WYLE LABORATORIES RESEARCH STAFF
Technical Memorandum 66-21

REVIEW OF PROPOSED CONTROL
AND INSTRUMENT ROOM FOR BUILDING 4776,
MARSHALL SPACE FLIGHT CENTER
HUNTSVILLE, ALABAMA

May 1966

Figure 1a. Proposed Construction

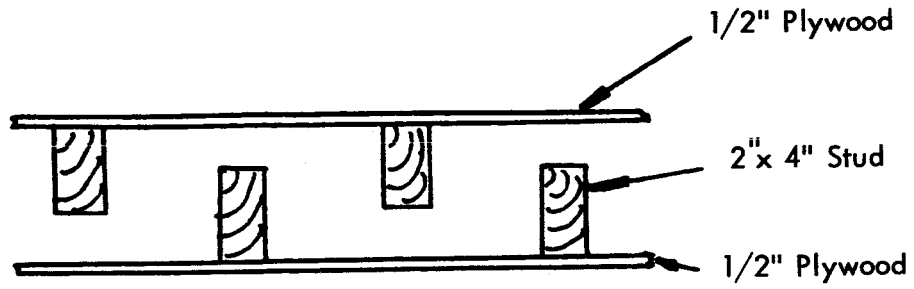
The following description is taken from a sketch provided by R-AERO-AMG, (Reference 2). The proposed room would be constructed with staggered 2 x 4 inch studs with 1/2 inch plywood attached to both sides to produce a double wall construction. See Figure 1a. The inner and outer walls are attached at the top and bottom to a 2 x 6 inch board. A double ceiling is provided, and the construction uses wood and glue. A double window facing the jets is included to allow the facility controller to view the gas flows and instrument rakes etc.

The immediate criticism of the instrument room, must be that the sound absorption features of the proposed construction are not sufficient. The proposed construction contains numerous examples where the double wall technique is jeopardized by direct connection between the inner and outer walls. This will remove the full advantages of this form of sound insulation. It should also be noted that a double floor is not provided.

The double windows, as designed, include 2 x 6 inch members connecting the inner and outer walls. These were included to seal the space between the glass panes to allow control of window misting. However, this does provide a direct path between the two walls. Therefore, it is recommended that the two windows be constructed separately. If any sealing is necessary it could be accomplished using flexible polyethelene sheet.

The proposed ceiling construction also connects the inner and outer room, as does the construction of the door frames. Both of these techniques should be eliminated. The two rooms should be completely separate, except through the connection at the floor. Double doors are not specified, but these are necessary if the full advantages of the double wall construction are to be realized.

- a) The double room construction should be modified so that there is absolutely no connection between the inner and outer rooms. This includes the ceiling of both rooms, and the construction of double doors.
- b) The proposed facility does not call for a double floor. It is recommended that such a false floor be included, and a suggested design would have the floor suspended from the inner wall, and supported at intervals by vibration isolators, or isomode pads. The space under the floor could also contain an absorptive blanket. This construction should eliminate the possibility of vibration from the facilities being transmitted into the instrument room through the concrete base of the building.

Figure 1b. Recommended Construction

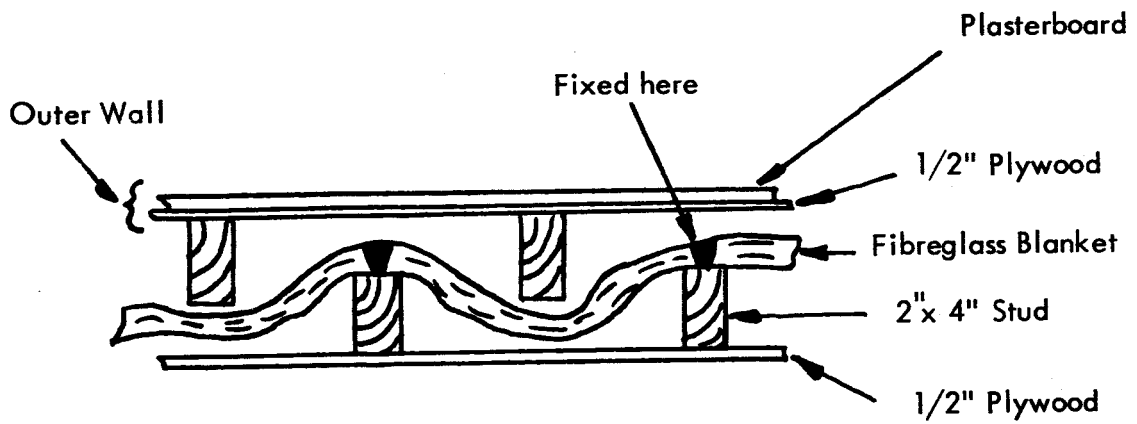
- e) The addition of a fiberglass blanket, of some other sound absorption material, between the two walls will be necessary to provide any reasonable reduction in the noise level. This fiberglass blanket would be tacked on to one wall only, so as not to constrain the movement of the two walls. A sketch shows this addition and the extra plasterboard layer in Figure 1b. Such a construction would be especially advantageous on the wall facing the nozzles.

- d) The use of plasterboard rather than plywood will produce a better sound reduction, because of its greater mass. However, it must be firmly mounted and sealed at the joints. It should prove advantageous to add an extra layer to the outer wall by tacking on plasterboard over the plywood.

The addition of the plasterboard and the acoustic blanket should double the mass of the wall, from about 3.0 pound/ft.² to 7.0 pound/ft.². The values given in References 3 and 4 suggest that a transmission loss of 45 dB can be expected for this type of construction, and the addition of another plasterboard layer on the inside wall will increase the transmission loss to near 50 dB. Therefore, for the expected noise levels of the jets, the sound level inside the modified room would calculate as 100 dB, re: 0.0002 dyne/cm².
